Appendix A

Response-to-comment

Lot Nos. 314 RP (Part), 315 (Part),
317 S.F, 317 S.G (Part), 317 S.H
(Part) & 317 S.I RP in D.D. 113,
Ma On Kong, Pat Heung,

Catchment Plan

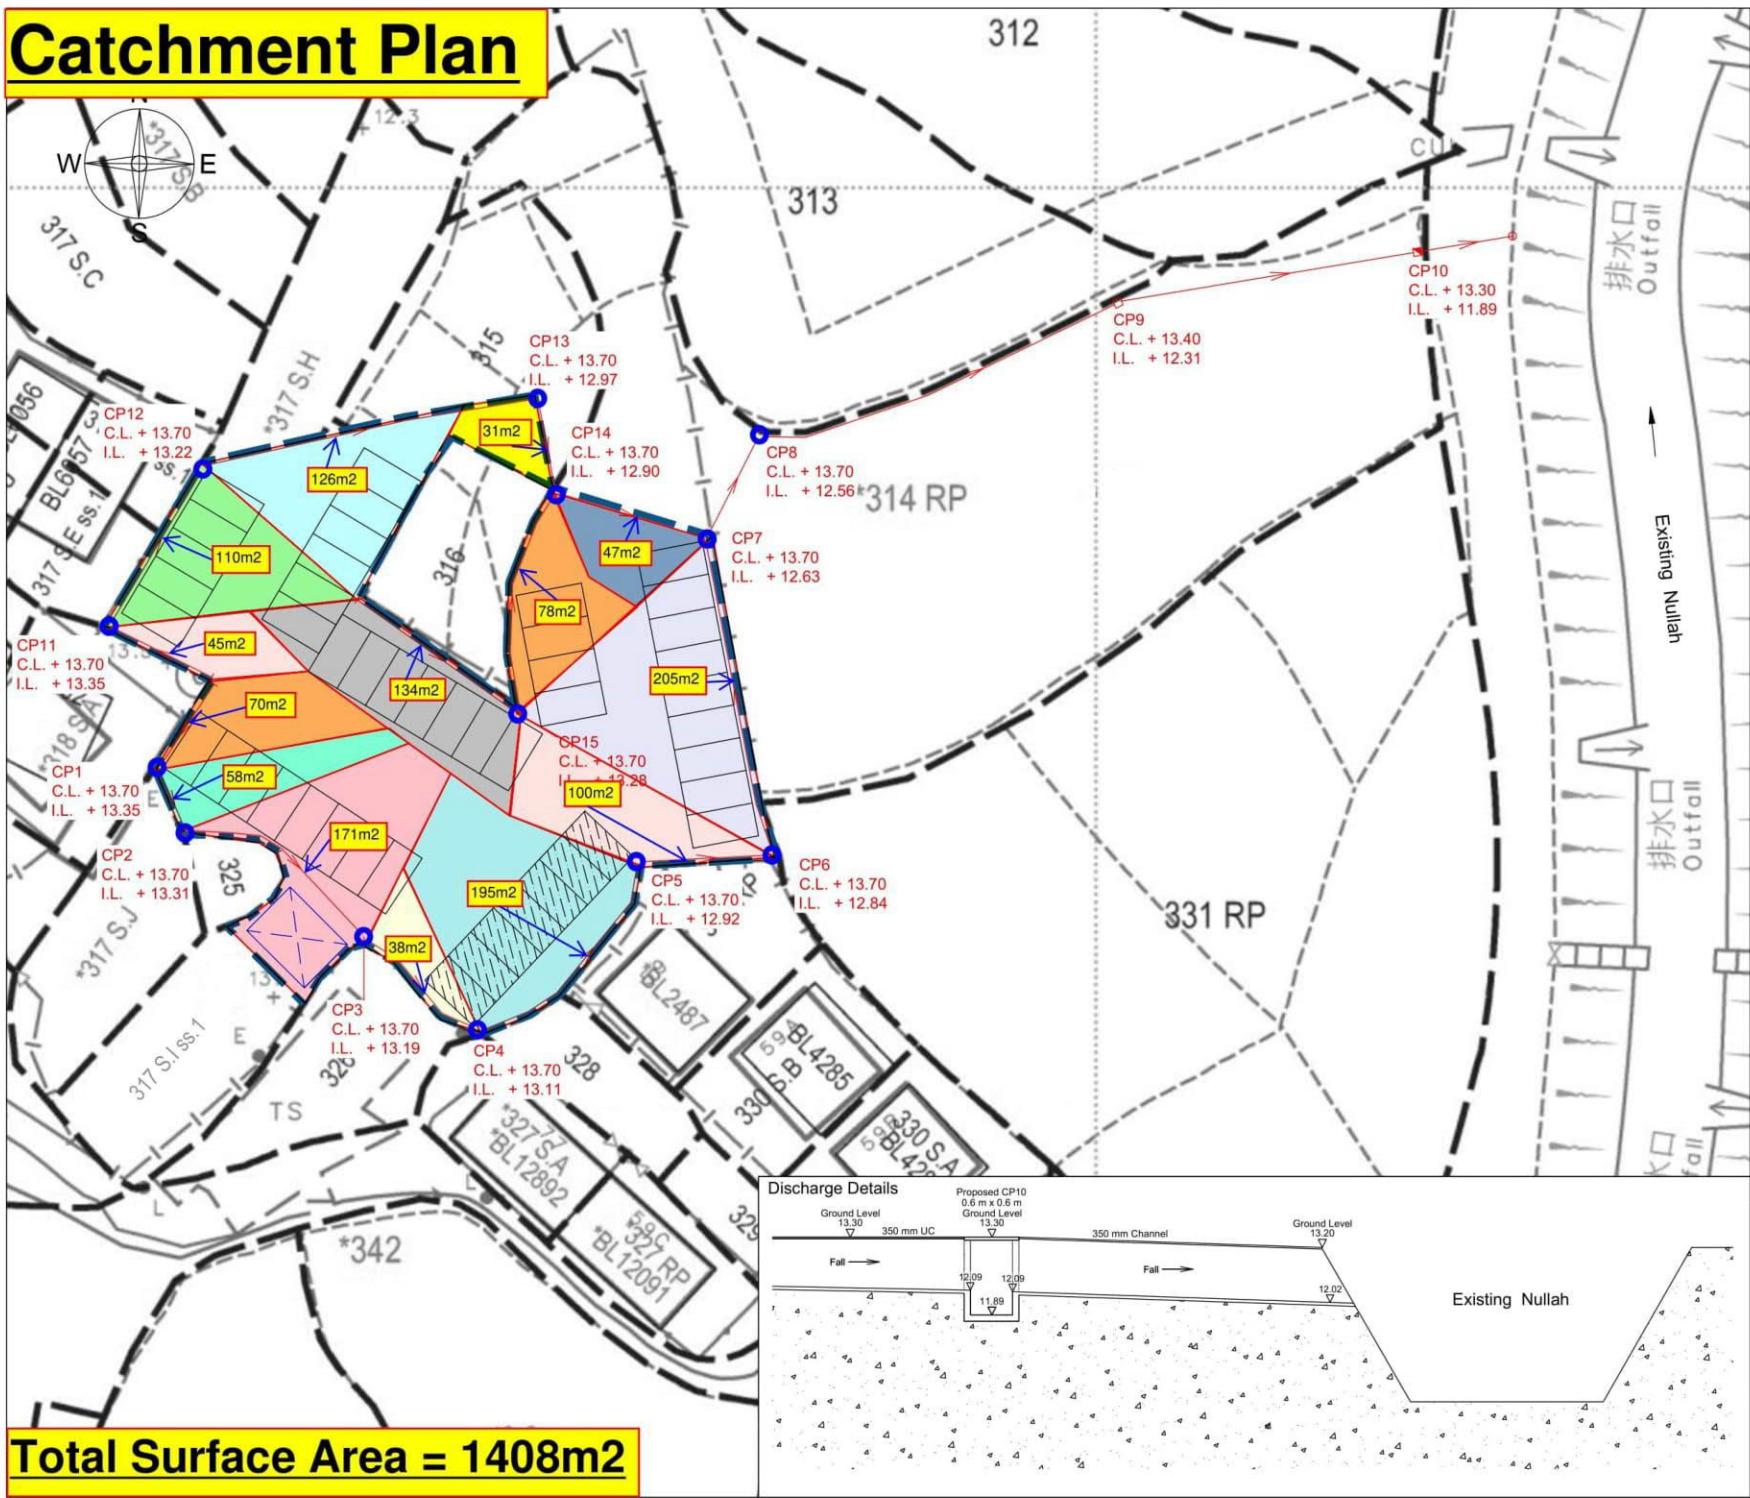
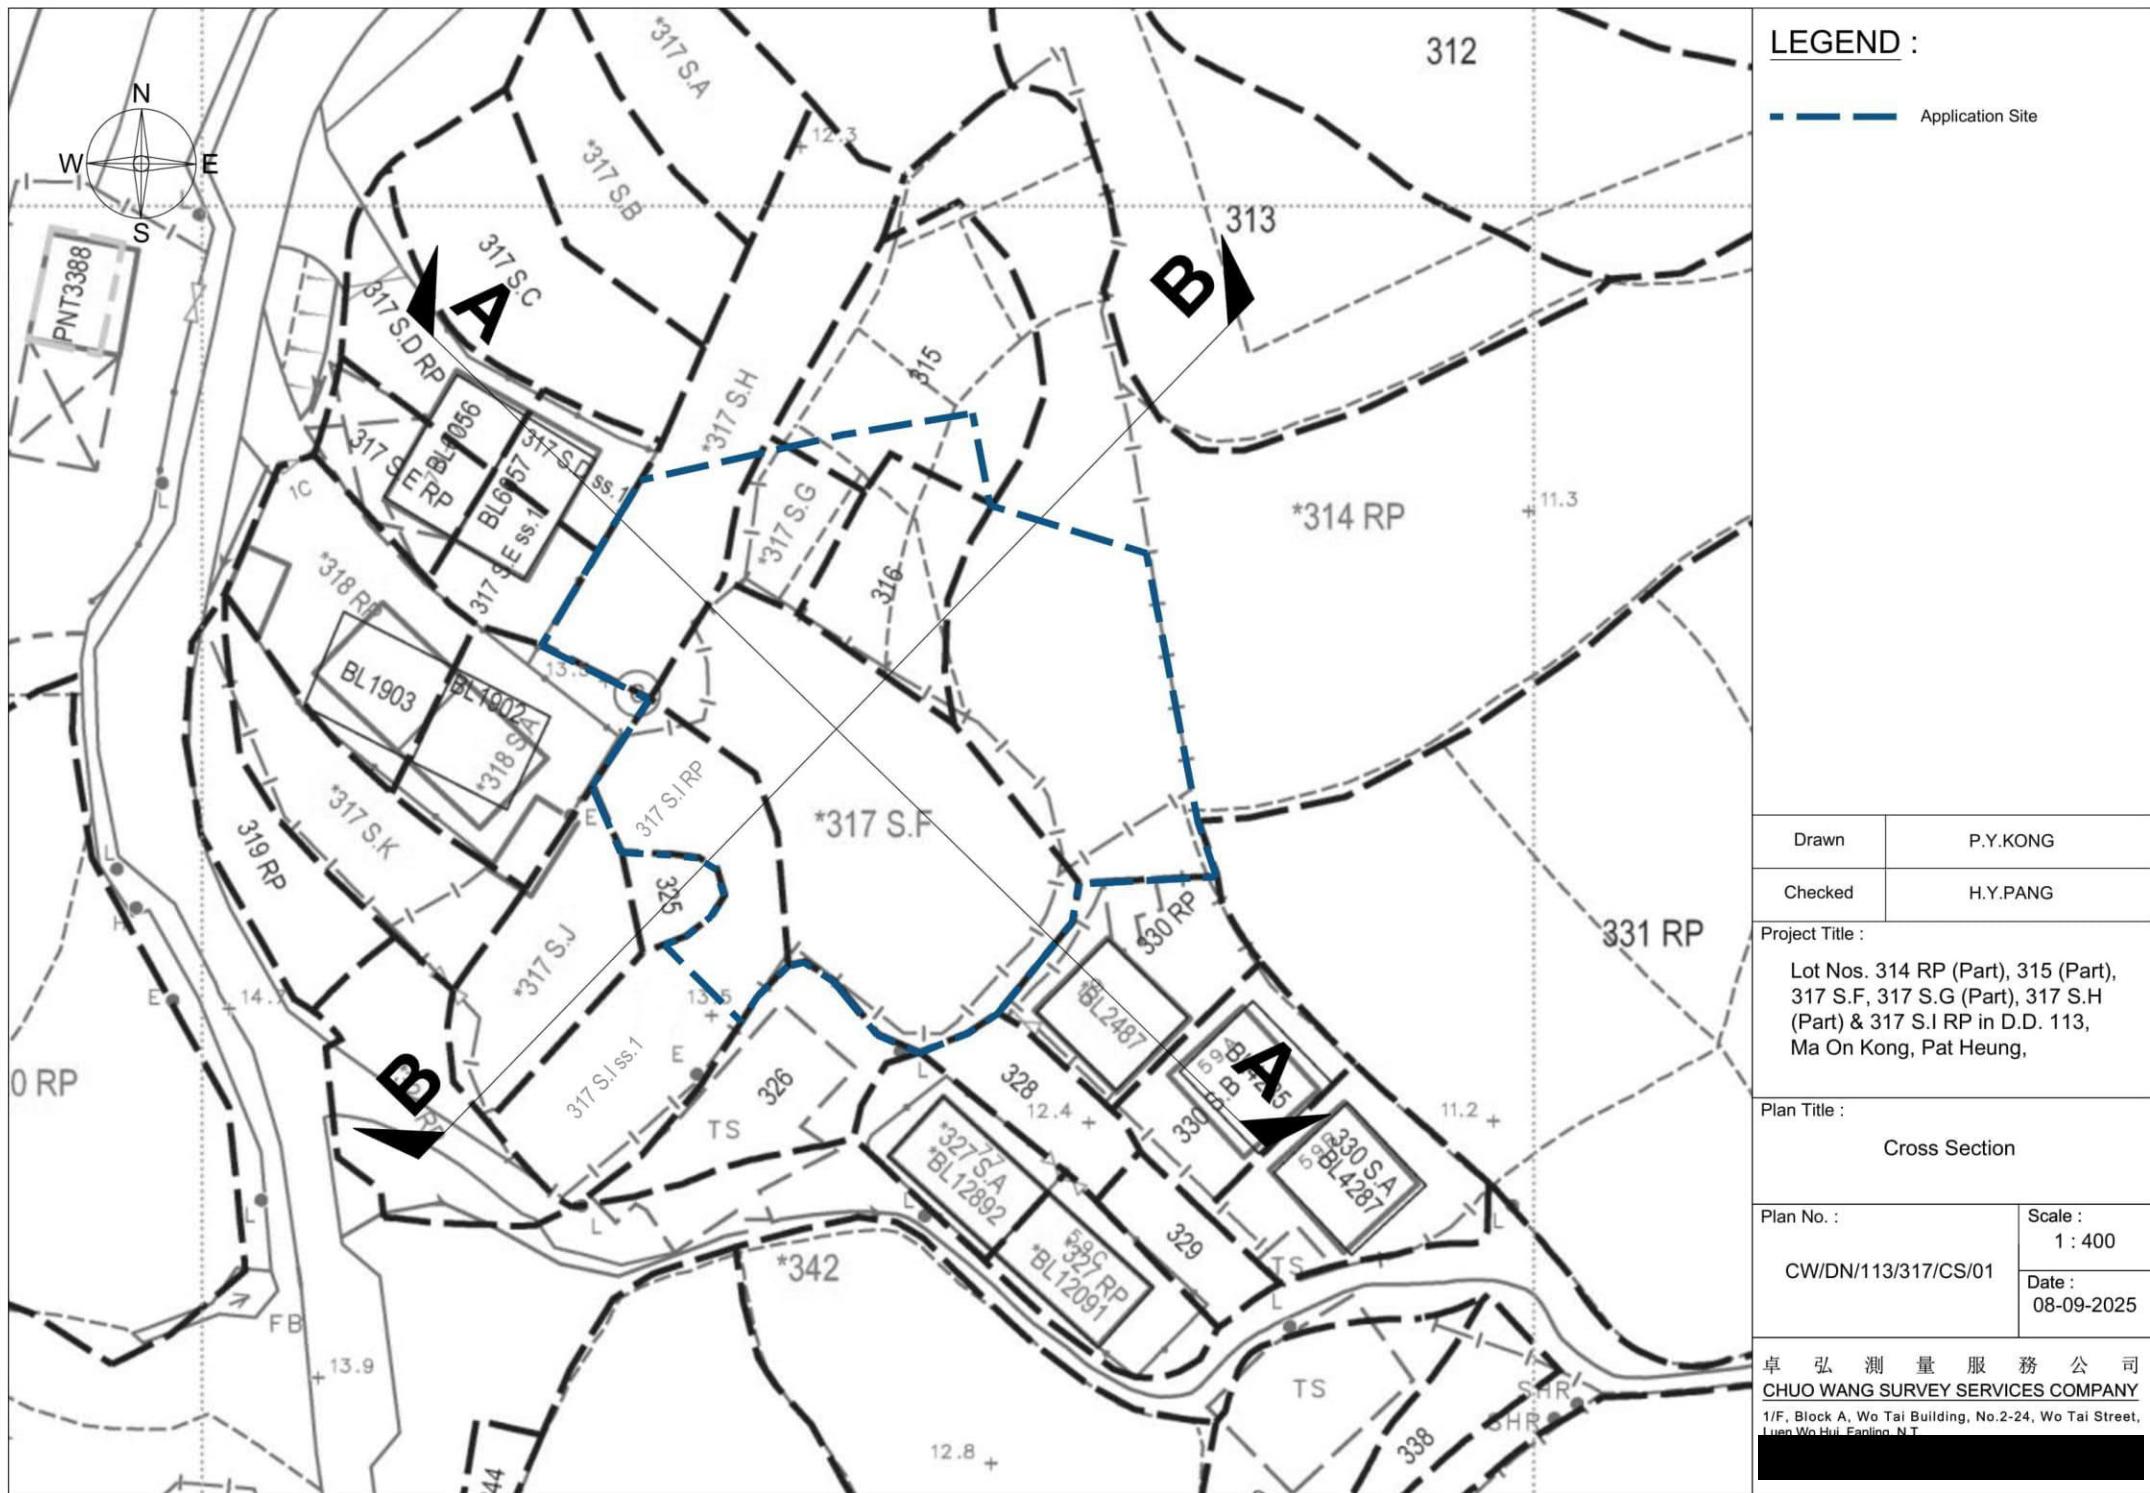
(g)	The size of the proposed site is 1,408.41m ² . However, the catchment area is 1,274.2m ² only. Please clarify and indicate the proposed catchment in drawing.	The catchment plan is attached.
